Addendum No. 1
August 12, 2021

Project: DGR Engineering
Lot 4, Block 19 Dawley Farm Village Addition
2932

Architect: Architecture Incorporated

BREAKROOM CASEWORK - SD-01
 SCALE: 1/4" = 1'-0"

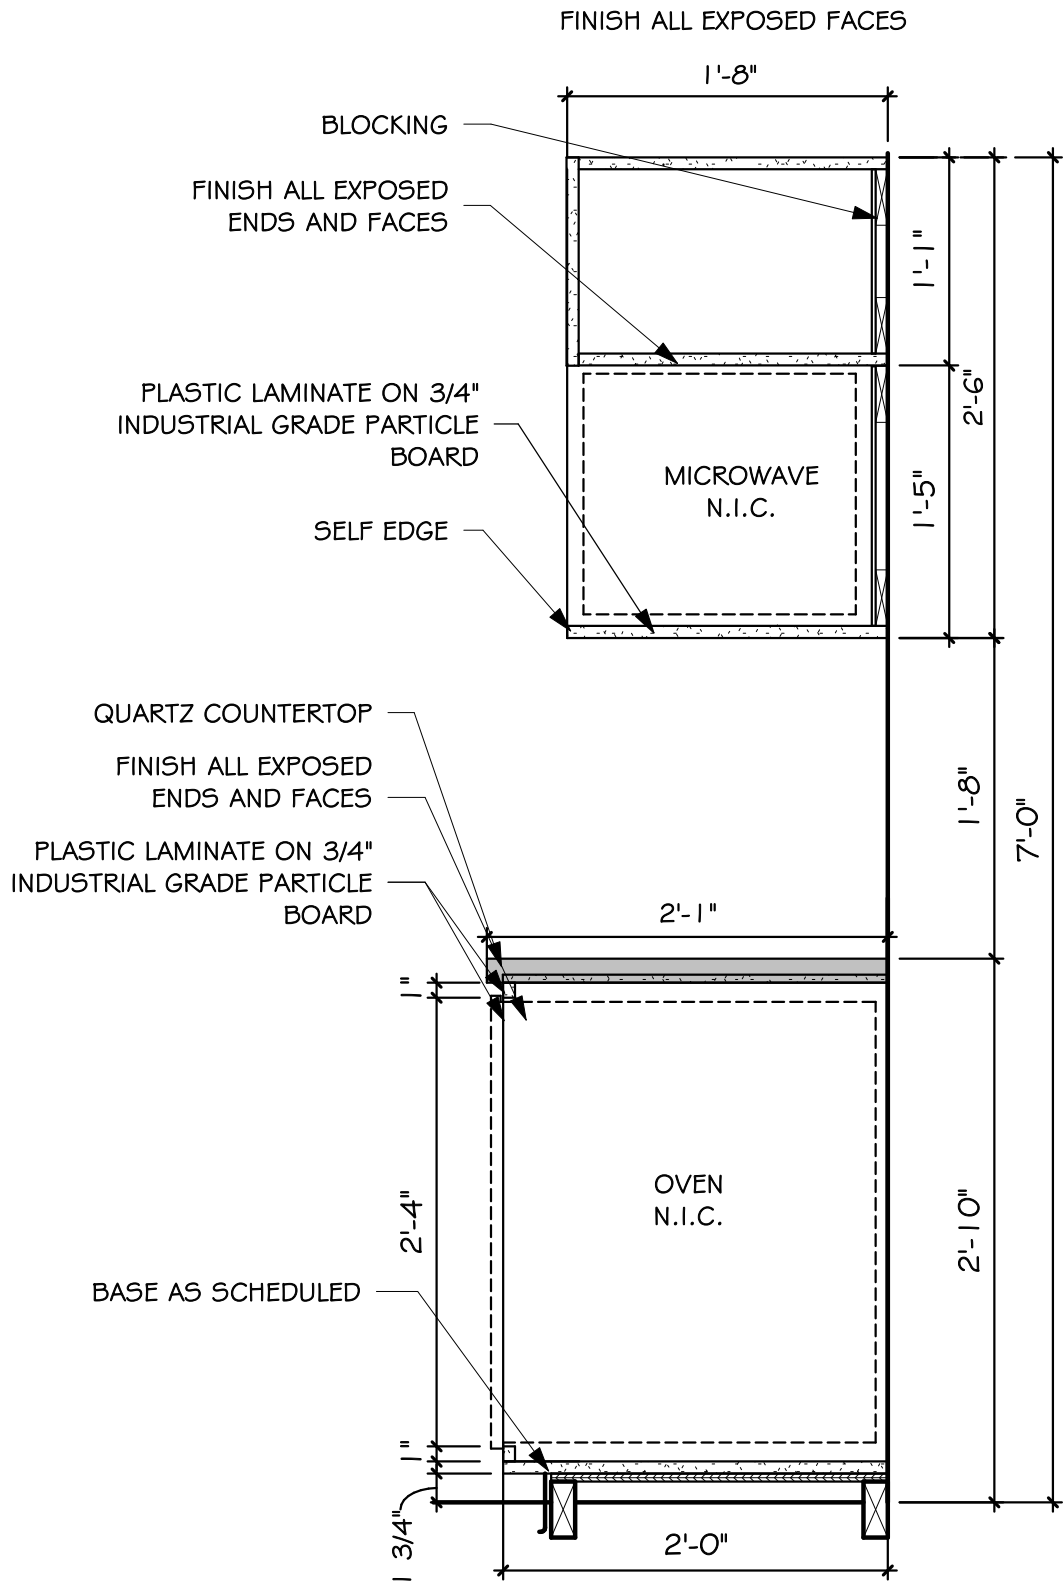
- a) First Floor Plan – Corridor running adjacent to UNISEX 105, UNISEX 104 and CONF. 136 is to be labeled as HALL 107 and finished as denoted in the Room Finish Schedule.
- b) Breakroom 150 – modify casework layout and electrical service for owner supplied oven, revise interior elevation F/4.50 as shown on the attached Supplemental Drawing SD-01. Casework section at owner provided oven as shown on the attached Supplemental Drawing SD-02.
 - i) All appliances shown in SD-01 will be owner provided contractor installed. This includes (3) microwaves, (2) Refrigerators with water service (1) Dishwasher and (1) Oven. General Contractor to coordinate with owner supplier for installation.

DGR OFFICE
FIRST FLOOR PLAN - PLUMBING & HEATING

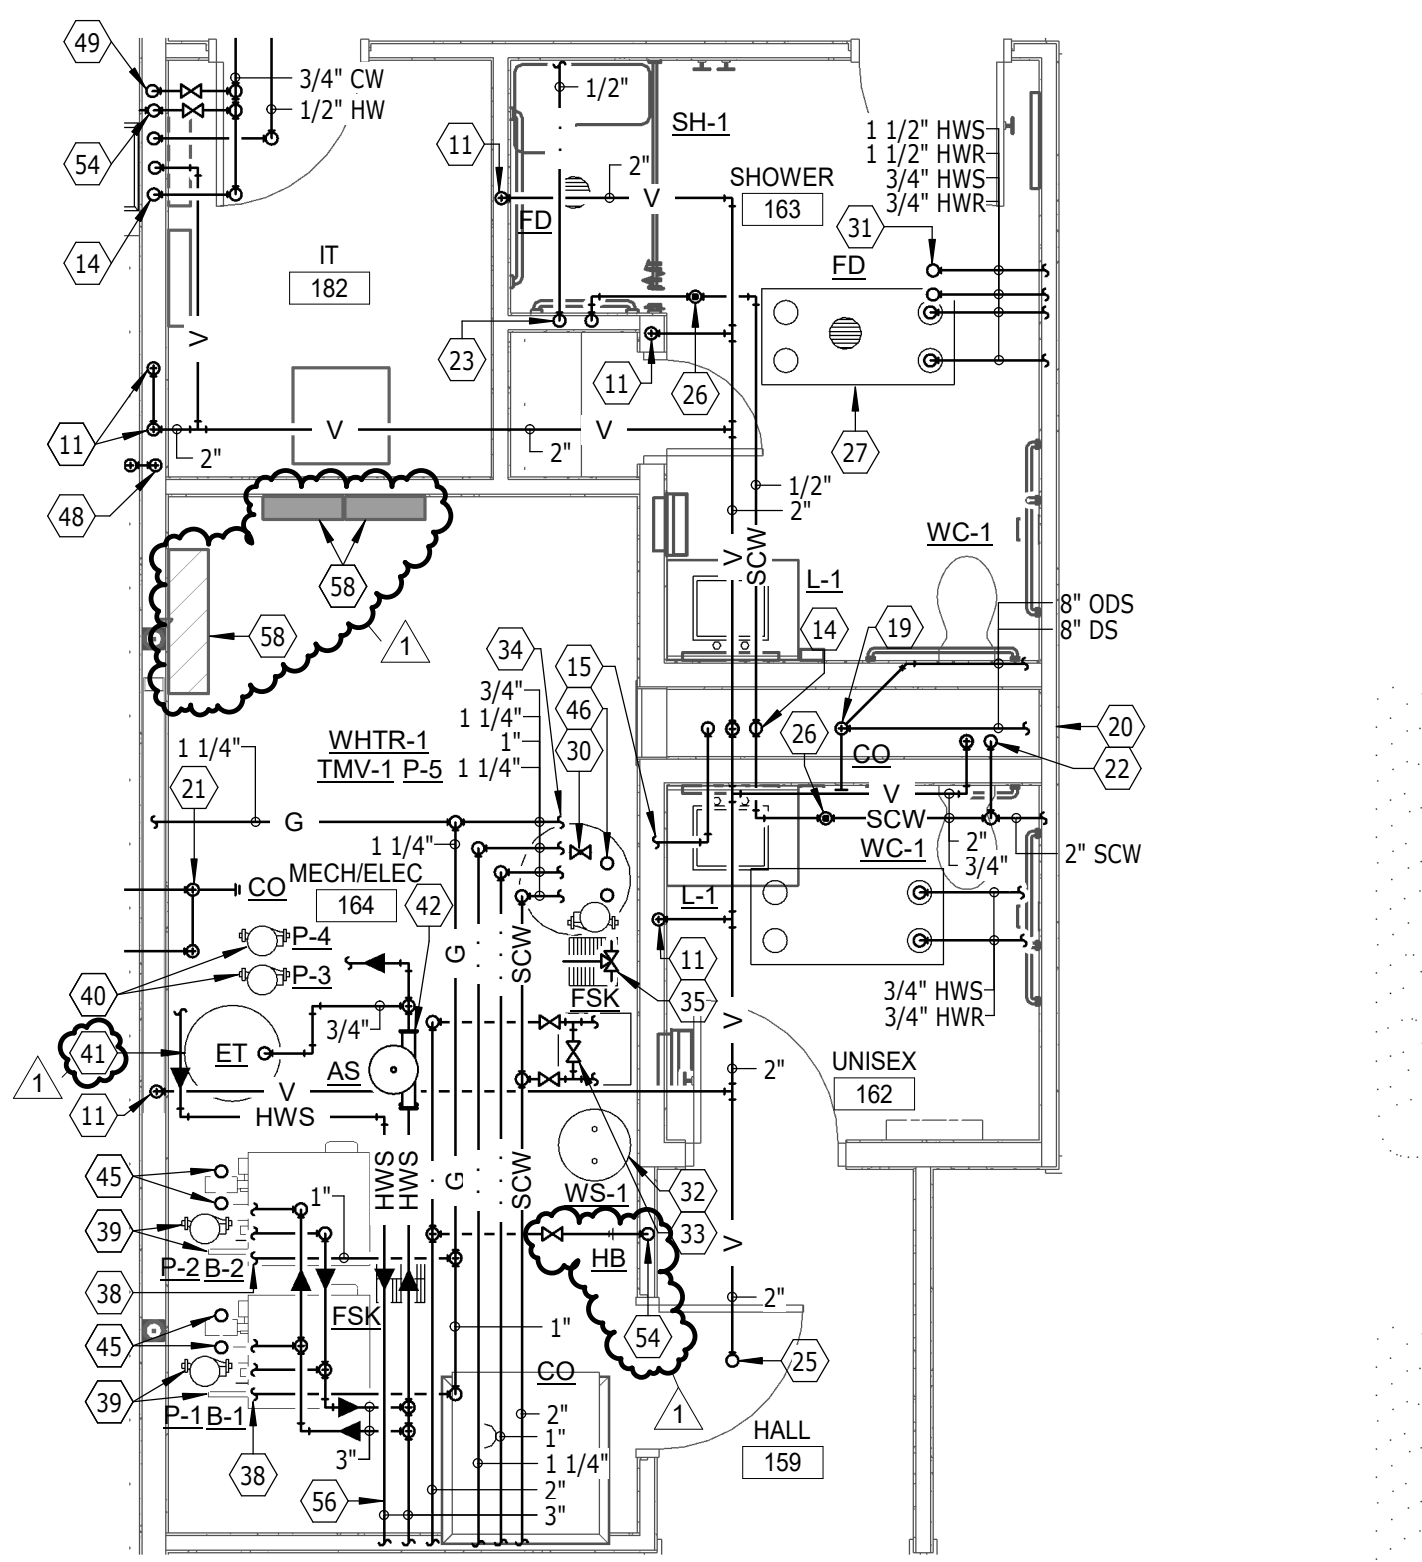
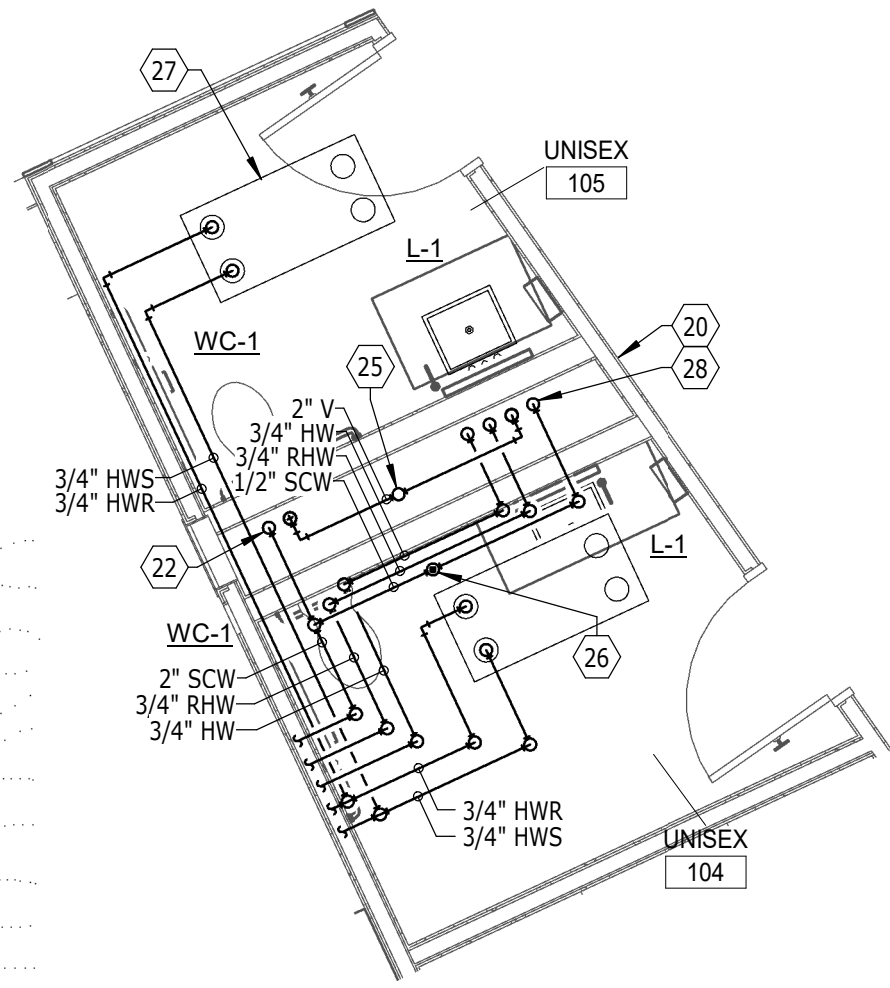
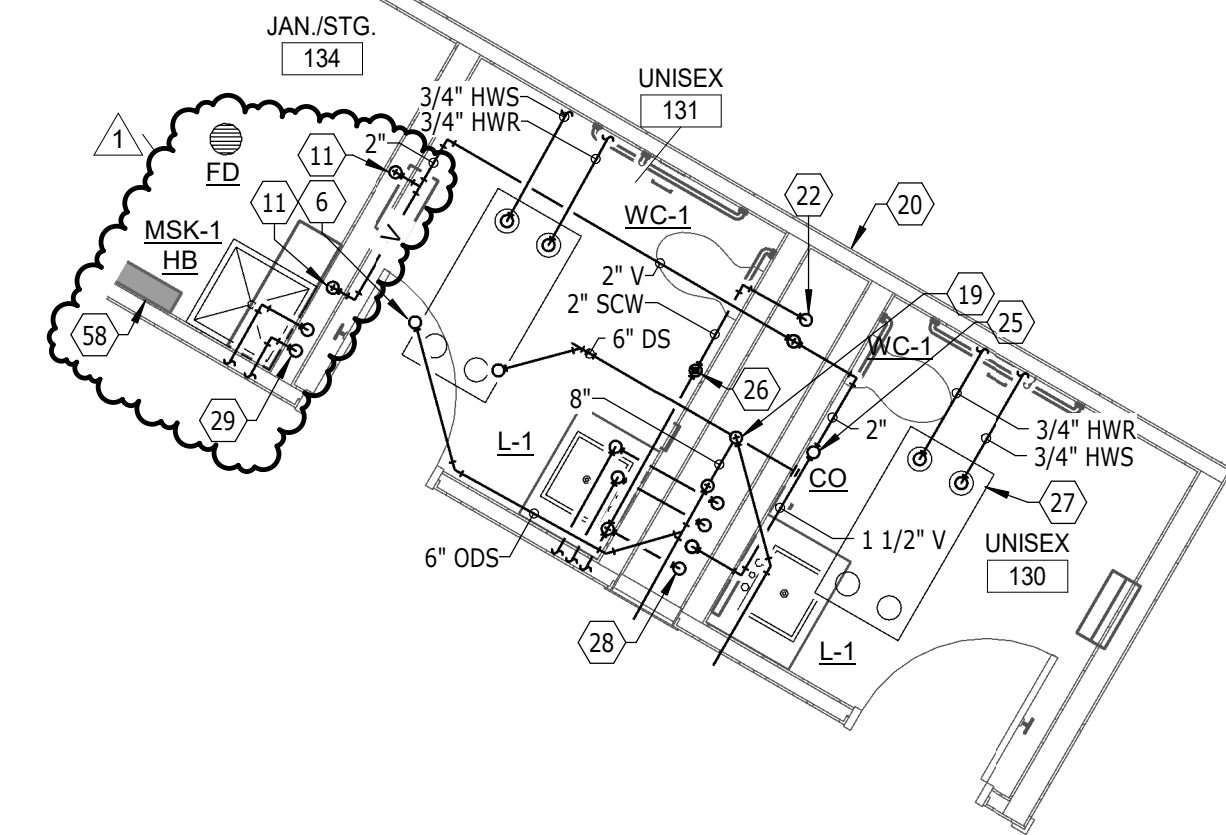
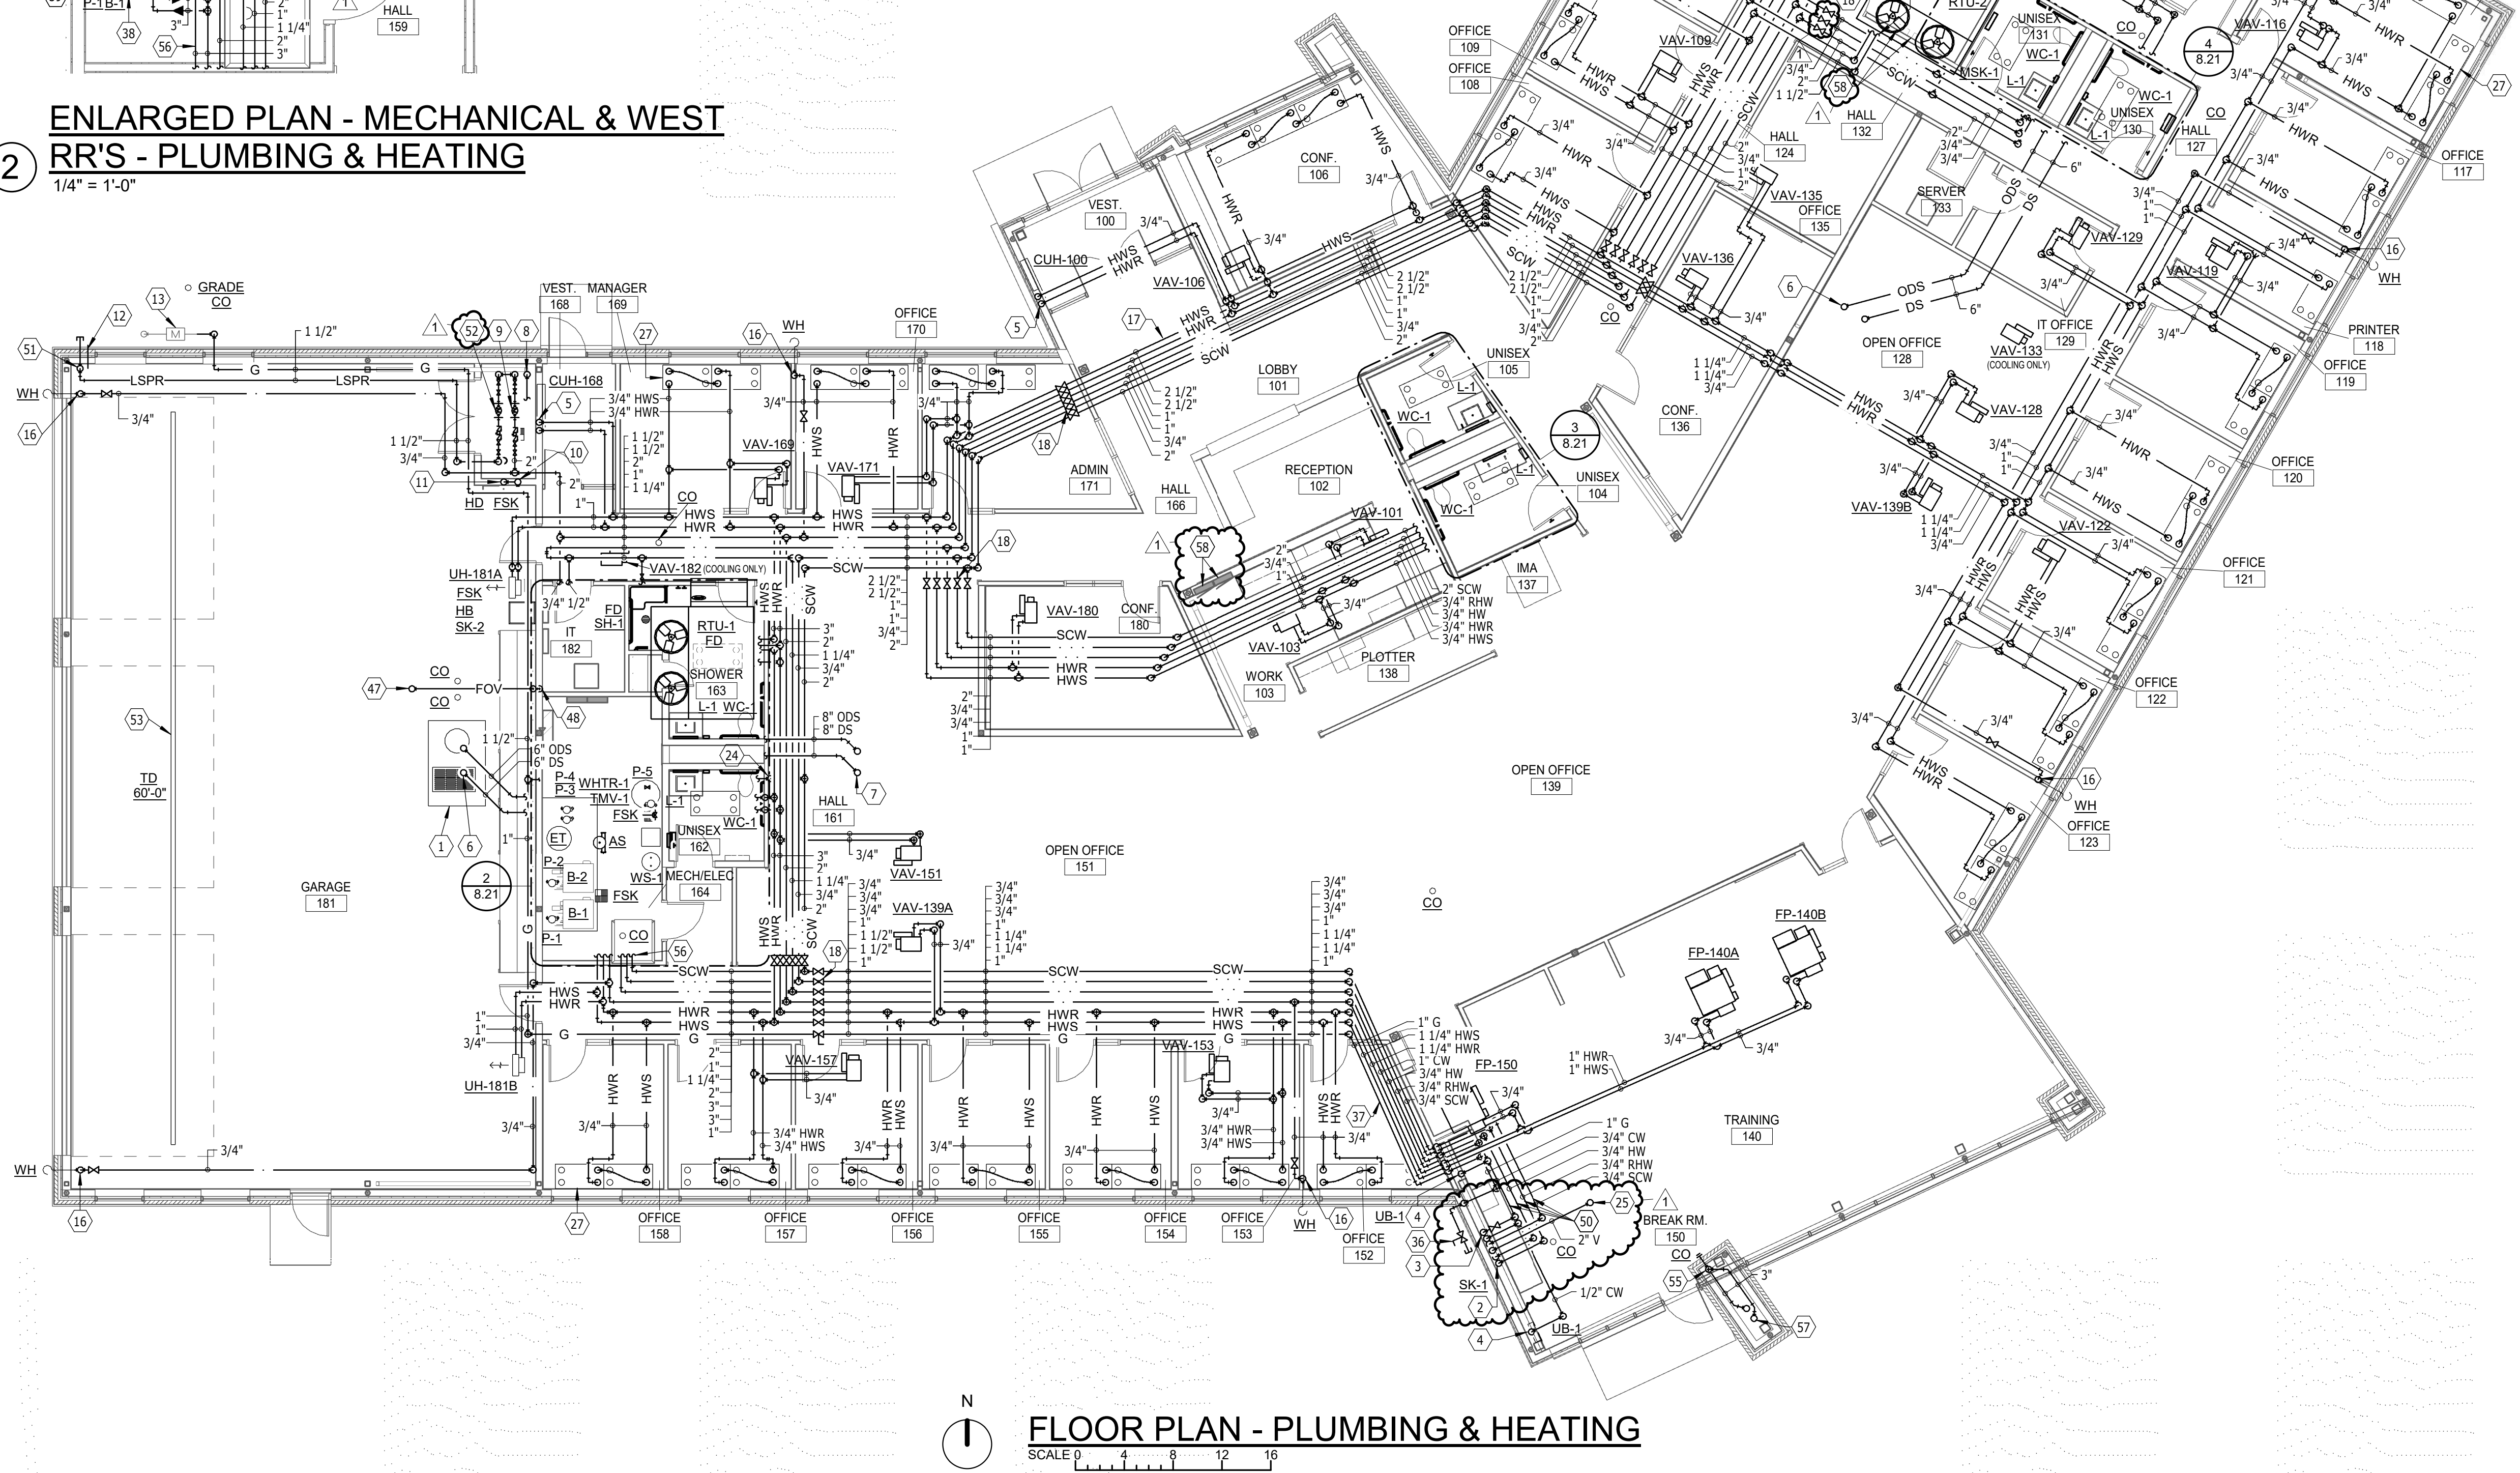
5) 8.21 – FIRST FLOOR PLAN – PLUMBING & HEATING

- a) Revise irrigation meter keynote to include more detail about the irrigation meter installation per City of Sioux Falls requirements.
- b) Revise specification of boiler system expansion tank to be Bell & Gossett Model D-144V.
- c) Remove undercounter hub drain, including associated vent piping, in “Break Rm 150”.
- d) Add hose bibb, with shut-off valve, in “Mech/Elec 164”.
- e) Add isolation shut-off valves for piping serving “Jan/Stg 134”, “Unisex 131”, and “Unisex 130”.
- f) Add floor drain, including corresponding vent piping, in “Jan/Stg 134”.
- g) Add keynotes signifying electrical equipment that will require specific coordination of pipe routing with electrical contractor.
